SERVICE BULLETIN MAINTENANCE OF WAY EQUIPMENT

DATE: 7-9-2002 **BULLETIN NO:** 02-017

TITLE: 199948 SOFTWARE UPGRADE GROUP

PRODUCT SERIES / MODEL: W96 Series E3 TOP GUN™ Spike Drivers

FIGURE 3
WORK / TRAVEL SELECT ELECTRICAL SCHEMATIC

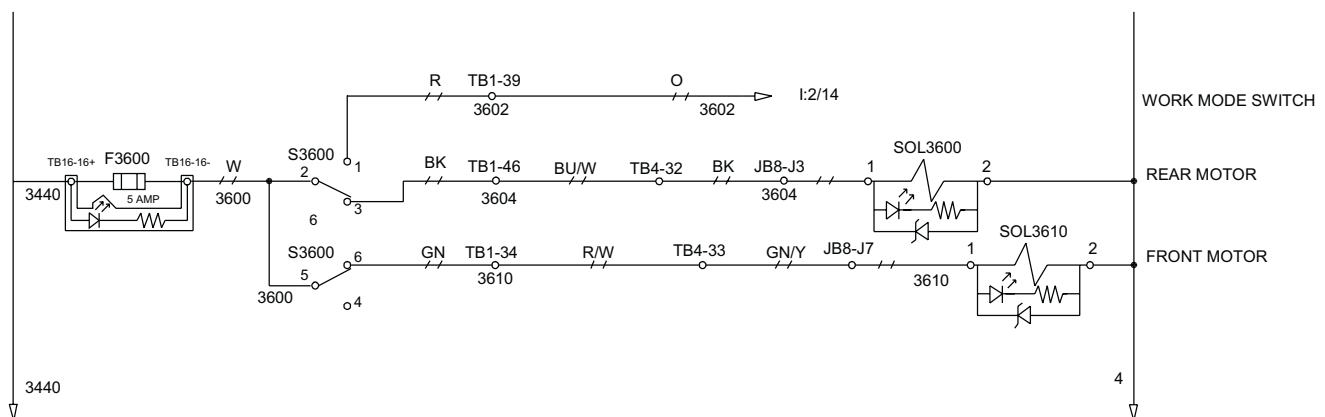
1. In the Air Panel, remove the Work Mode switch S2580 and the Motor Speed switch (added previously).
2. In the Control Box, remove the cables that were connected to the Work Mode switch S2580 and the Motor Speed switch (added previously). Plug the cable hole in the Control Box with the hole seal (8).
3. In the Air Panel, install the Select switch S3600 (12).
4. Install the Cable (4) from the Control Box to the Select switch S3600. Wire and label as listed in the following Chart. Seal the Cable (4) in the Control Box with the Cable Grip (3) and Lock Nut (7).

5. Connect a Jumper wire (14 or 15) between the Select switch S3600-2 and S3600-5 terminals. Label wire #3600.
6. In the Control Box and CPU Box, locate the Red / White and Blue / White conductors in the CNTL-CPU cable. Wire and label as listed in the following Chart.

7. In the CPU Box, locate the Black and Green / Yellow conductors in the J8 Turck Block cable. Wire and label as listed in the following Chart.
 - 7.1. Disconnect wire #3600 from Output O:17/17 and reconnect it to TB4-32. Re-label wire #3604.

8. In the Control Box, install a 5 amp Fuse (11) at TB16-16.
9. Test the Work / Travel Select switch wiring modification as follows:
 - 9.1 Turn on the Master Disconnect switch.
 - 9.2 DO NOT start the engine.
 - 9.3 Pull out the Neutral Start switch.
 - 9.4 Place the Select switch S3600 in the LO position and verify:
 - a. PLC Work Mode Input I:2/14 is ON.
 - b. Rear Propel Motor solenoid SOL3600 is OFF.
 - c. Front Propel Motor solenoid SOL3610 is OFF
 - 9.5 Place the Select switch S3600 in the MID position and verify:
 - a. PLC Work Mode Input I:2/14 is ON.
 - b. Rear Propel Motor solenoid SOL3600 is OFF.
 - c. Front Propel Motor solenoid SOL3610 is ON.
 - 9.6 Place the Select switch S3600 in the HI position and verify:
 - a. PLC Work Mode Input I:2/14 is OFF.
 - b. Rear Propel Motor solenoid SOL3600 is ON.
 - c. Front Propel Motor solenoid SOL3610 is ON.

FIGURE 4
HYDRAULIC SOFT-START ELECTRICAL SCHEMATIC

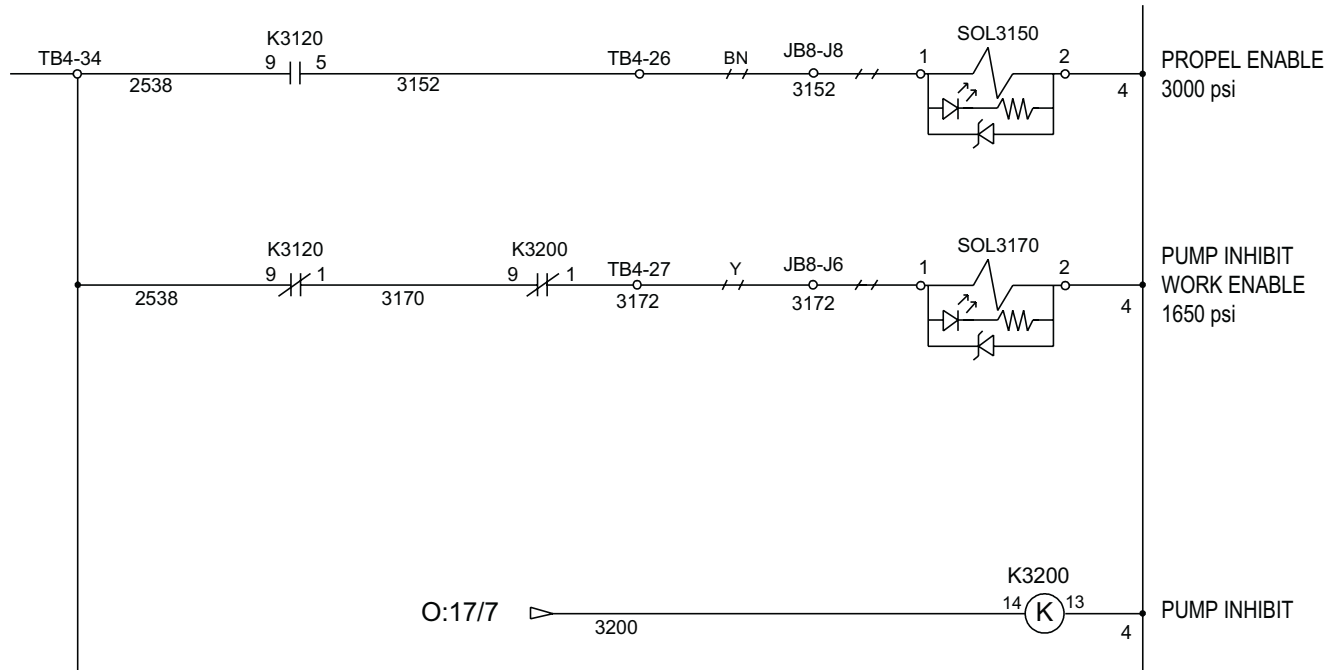
Note: Output O:17/7 is needed for the Hydraulic Soft-Start Feature. The Work / Travel Select Switch modifications must be completed before the Hydraulic Soft-Start Feature can be added.

1. In the CPU Box, install the Relay (16), Relay Socket (10) and Relay Bail (9) on the top of the TB-4A DIN rail. Label Relay K3200. Wire Relay as follows:

- 1.1. **Important:** Verify that there is no wire connected to Output O:17/7 and that the black wire #3604 of the J8 Turck Block cable is connected to TB4-32. If not, complete the Work / Travel Select Switch modification before proceeding.

- 1.2. Connect a White wire (15) from Output O:17/7 to Relay K3200-14. Label wire #3200.
 - 1.3. Connect a Black wire (14) from Relay K3200-13 to GND on TB4. Label wire #4.

- 1.4. Disconnect wire #3170 from Relay K3120-1 and reconnect it to Relay K3200-1. Re-label wire #3172.
 - 1.5. Connect a White wire (15) from Relay K3120-1 to Relay K3200-9. Label wire #3170.

2. Test the Hydraulic Soft-Start Feature wiring modification as follows:
 - 2.1 Turn on the Master Disconnect switch.
 - 2.2 DO NOT start the engine.
 - 2.3 Pull out the Neutral Start switch and note Output O:17/7 and the Work Enable solenoid SOL3170.

**FIGURE 5
AUTO BRAKE ELECTRICAL SCHEMATIC**

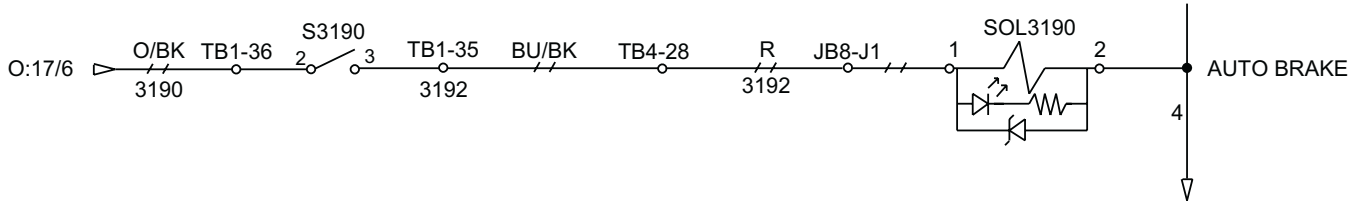
2. Plumb the Brake Inhibit pressure switch (17) into the right rear service brake air line using appropriate fittings and hoses, not supplied.
3. In the Control Box, re-wire the Auto Brake switch S2590 as follows:

- 3.1. Remove the White / Red wire #2538 from TB1-42 and reconnect it to TB1-36. Re-label wire #3190.
 - 3.2. Connect the Orange / Black wire of CTRL-CPU2 cable to TB1-36. Label wire #3190.

- 3.3. At TB1-35, re-label the Blue / Black wire #2590 as #3192 and the White wire #2590 as #3192.
 - 3.4. Re-label the Auto Brake switch S2590 as S3190.

4. In the CPU Box, re-wire the Auto Brake switch S3190 (formerly S2590) as follows:
 - 4.1. Disconnect the Red wire #3190 of JB8 cable from Output O:17/6 and reconnect it to TB4-28. Re-label wire #3192.

- 4.2. Disconnect the Blue / Black wire #2590 from Input I:2/12 and reconnect it to Output O:17/6. Re-label wire #3190.
5. In the CPU Box, wire the Brake Inhibit switch Input as listed in the following Chart:

**FIGURE 6
BRAKE INHIBIT ELECTRICAL SCHEMATIC**

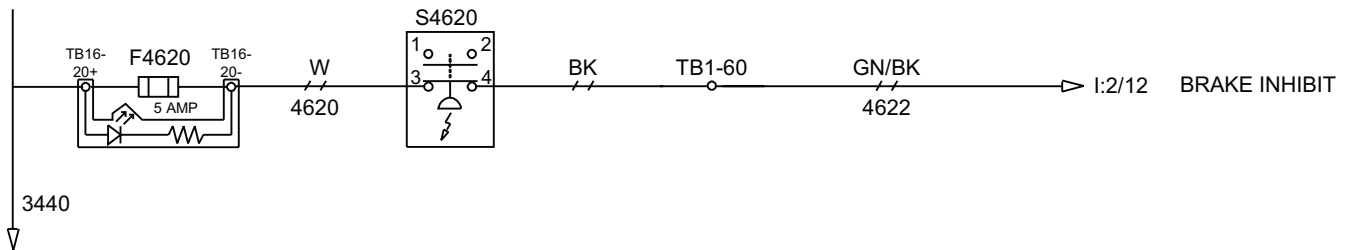
- 5.1. Locate the Green / Black wire in the CTRL-CPU2 cable and connect it to Input I:2/12. Label wire as #4622.

6. Install the Cable (6) from the Control Box to the Brake Inhibit pressure switch S4620 (17). Seal the Cable (6) in the Control Box using the Cable Grip (2) and Lock Nut (7).

7. In the Control Box, wire the Brake Inhibit pressure switch as listed in the following Chart:
- 7.1. Install a 5 amp Fuse (11) at TB1-20.
- 7.2. Locate the Green / Black wire in the CTRL-CPU2 cable and connect it to TB1-60. Label the wire as #4622

8. Test the Nipper / Gauger Brake Inhibit Feature wiring modification as follows:
- 8.1 See Figure 7 and Figure 8. Adjust the Brake Inhibit pressure switch as follows:

01-230 **FIGURE 7
BRAKE INHIBIT PRESSURE SWITCH**

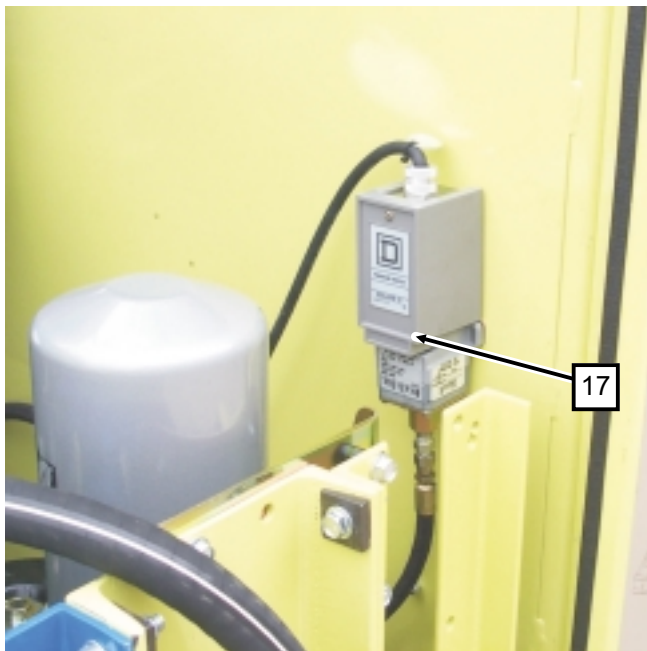
1. See Figure 7 and Figure 8. Mount the Brake Inhibit air pressure switch (17) to the engine side of the firewall behind the right operator using appropriate hardware, not supplied.

- Remove the cover from the pressure switch.
 - Adjust the thumb wheel (A) to a setting of 20 - 30 PSI (1.38 - 2.07 bar).
 - Re-install the cover on the pressure switch.

FIGURE 9
DRIVER DISPLAY FLOW CHART

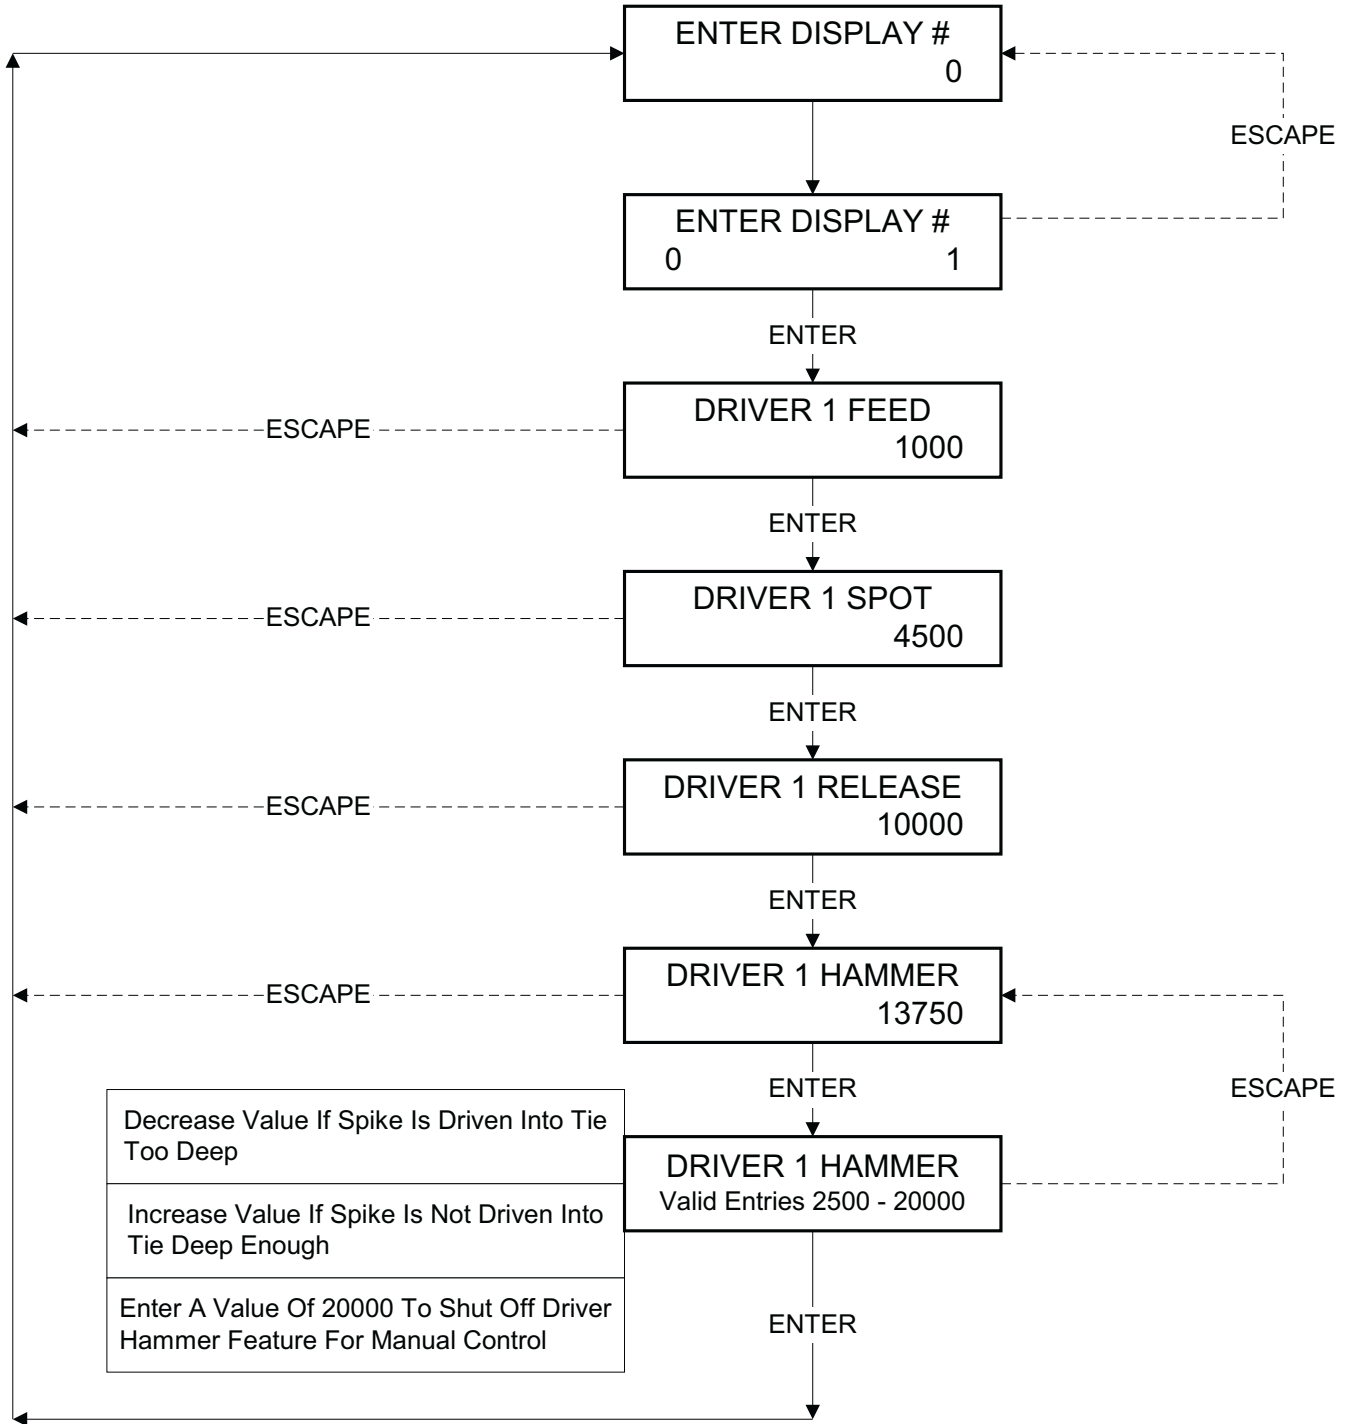
1. **DRIVER #1** - See Figure 9
2. **DRIVER #2** - See Figure 9
3. **DRIVER #3** - See Figure 9
4. **DRIVER #4** - See Figure 9

4. The Driver Hammer value controls the automatic stopping of the driver cycle when the driver has driven the spike into the tie to a pre-set depth.
 - 4.1 The Driver Hammer value should be set to a value 3,750 (3-3/4") more than the Driver Release value.
 - 4.2 If it is desired to shut off the Driver Hammer Feature to allow the operator to manually stop the driver cycle, enter a value of 20,000.
